**TECHNICAL SERVICE BULLETIN**

**SUBJECT:** Lip Seal Change  
**Products Affected:** All AC8 Axial Telma Retarders  
**Effective Serial #:** 394334 and after

**#37 Lip Seal**  
**Effects Only:**  
 AC8 Model retarders (ex. AC82-45, AC82-70)  
 Before Serial 394334: VF400340  
 After Serial 394334: VF400360

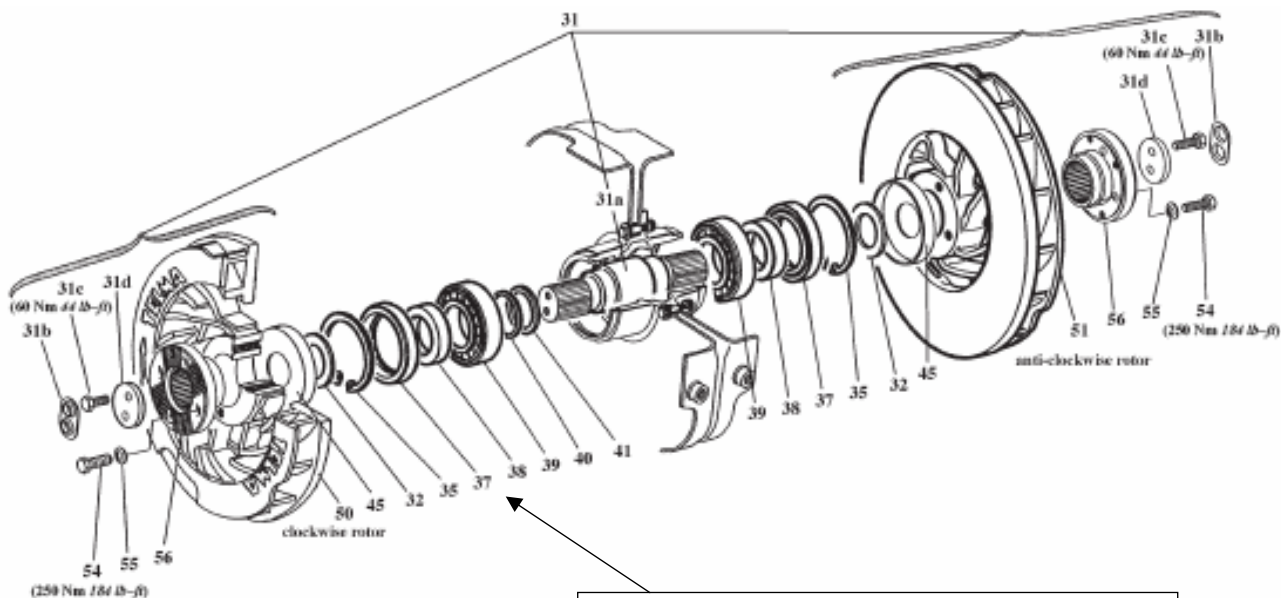
For serial numbers after 394334 the bearing Lip Seal has changed to part number VF400360. For serial numbers before 394334 the bearing lip seal is still part number VF400340.
